REMARKS

AMENDMENTS TO THE DRAWINGS:

Application No. 10/693,912

Fig.1

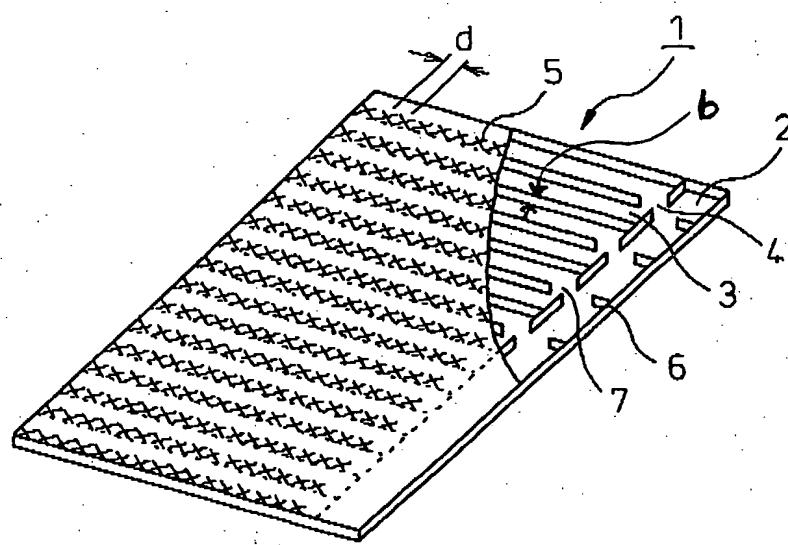
In Fig. 1, Applicants have amended the drawing to illustrate the height of a wall of waveguide 3 as labeled with the character "b," as supported on at least page 9, lines 7-8 of the as-filed specification, and page 6, line 29 of the specification as amended.

Fig.2

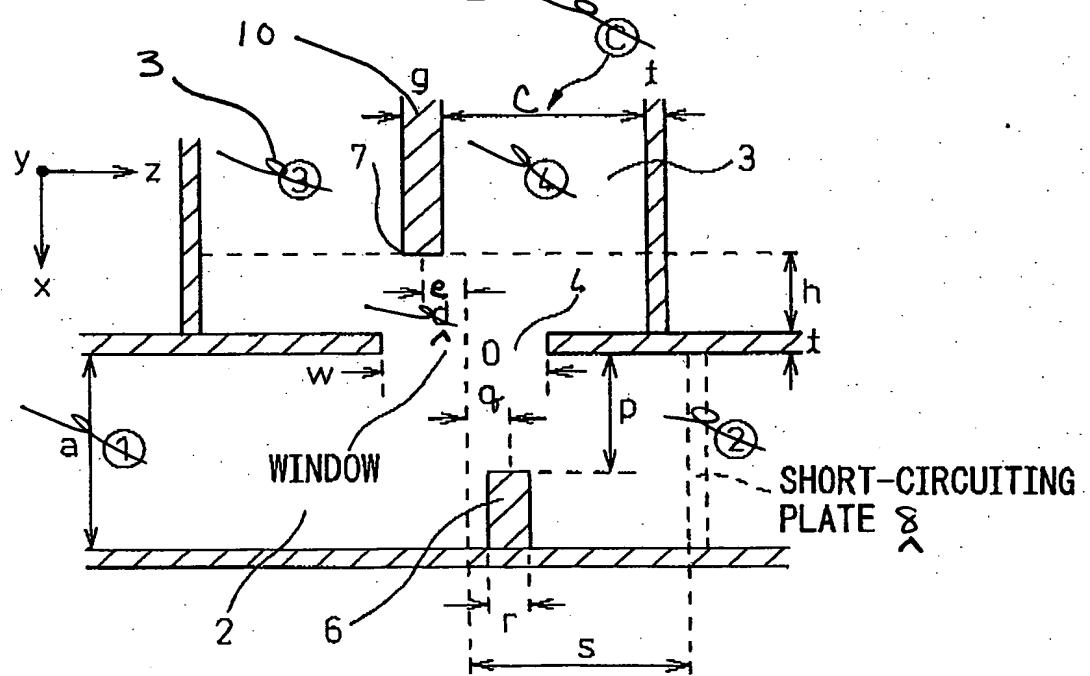
In Fig. 2, all encircled numbers have been removed and some have been replaced with equivalent identifier characters and lead lines. Waveguide 3 has been indicated by reference number 3 and a lead line. The common wall between the two waveguides 3 has been identified by reference number 10 and a lead line, as supported on at least page 9, lines 11-13 of the as-filed specification. The z dimension "d" has been replaced by reference character "e" in order to distinguish it from "d" used to identify another variable in Fig. 1. Reference numeral 8 has been added to the words "short-circuiting plate" as supported on at least page 8, lines 26-36 of the as-filed specification.

Fig. 3

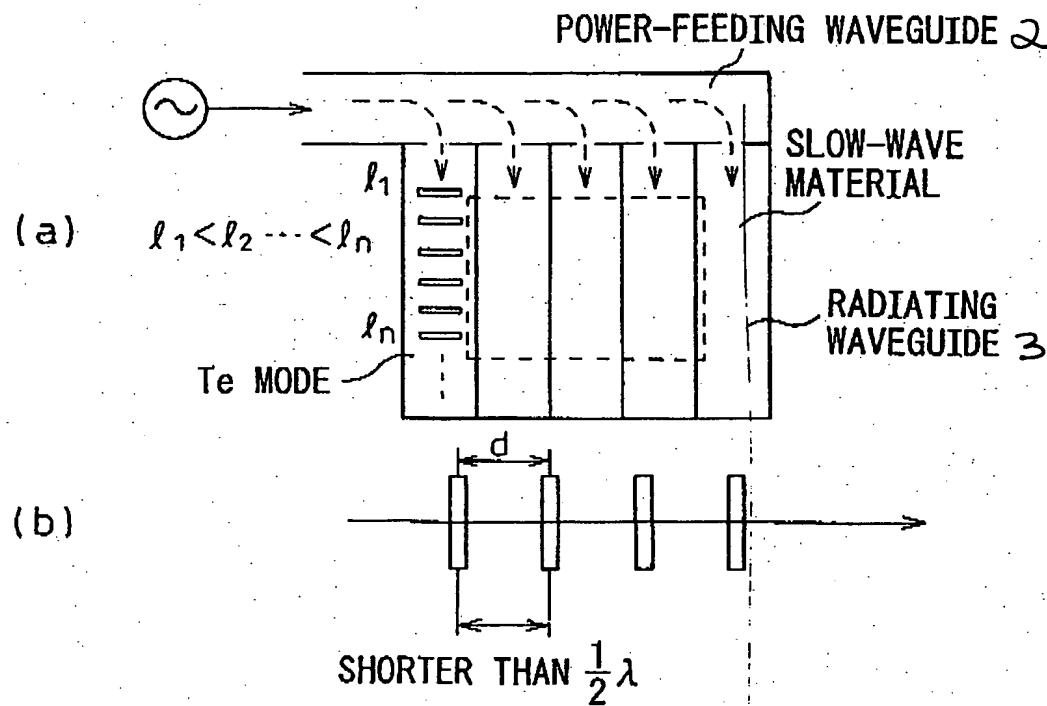
In Fig. 3, Applicants have added reference numeral 2 to the words "power-feeding waveguide" and reference number 3 to the words "radiating waveguide" as supported on at least page 10, lines 20-31 and Fig. 1 of the as-filed specification.

Fig. 4

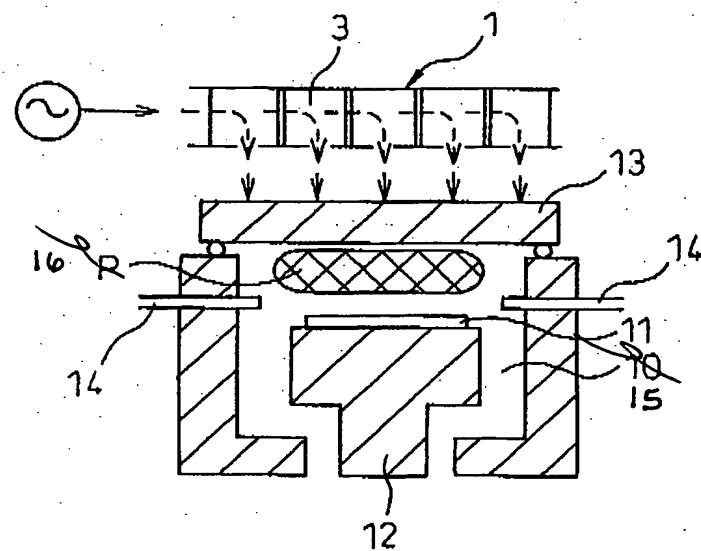
In Fig. 4, reference character P has been replaced by reference numeral 16. Reference numeral 10 has been replaced with reference numeral 15, to distinguish the chamber from the previously identified common wall 10.

Fig. 6

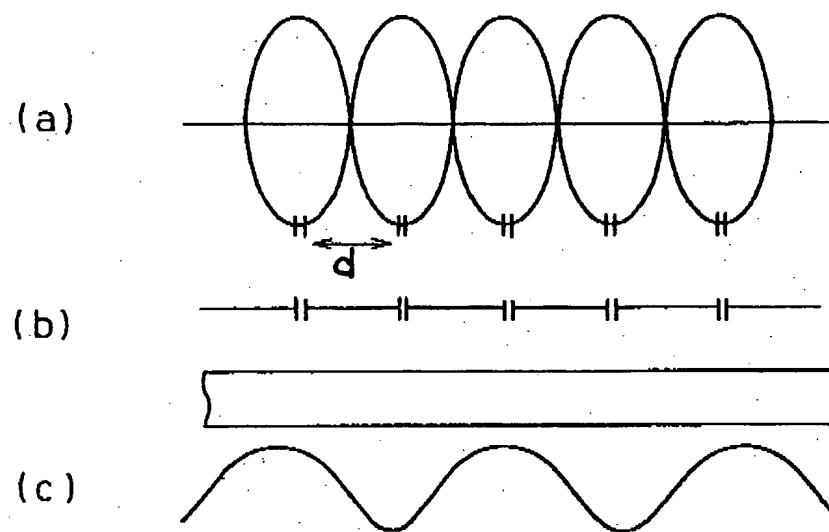
In Fig. 6, the arrow-marked dimension between adjacent slots has been labeled with reference character "d."

Fig. 8

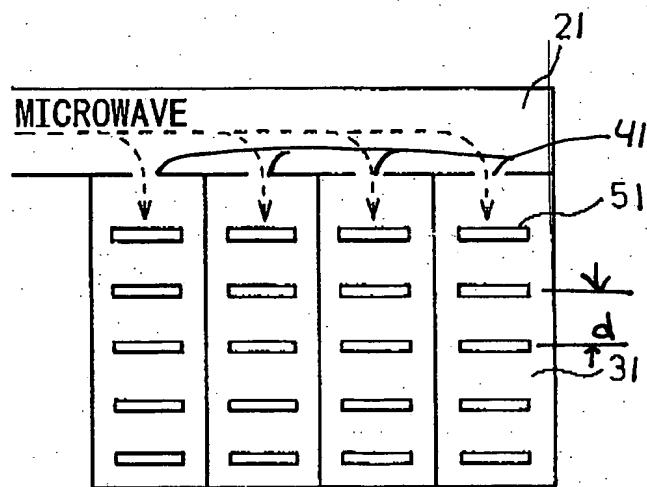
In Fig. 8, the reference numerals have been changed to indicate a different embodiment than similar structures in previous embodiments. Specifically, power-feeding waveguide 2 has been relabeled as power-feeding waveguide 21, unlabeled slots with dotted line arrows passing through them have been labeled as coupling windows 41, radiating waveguide 3 has been relabeled as radiating waveguide 31, and the distance between adjacent slots has been identified with reference character "d."
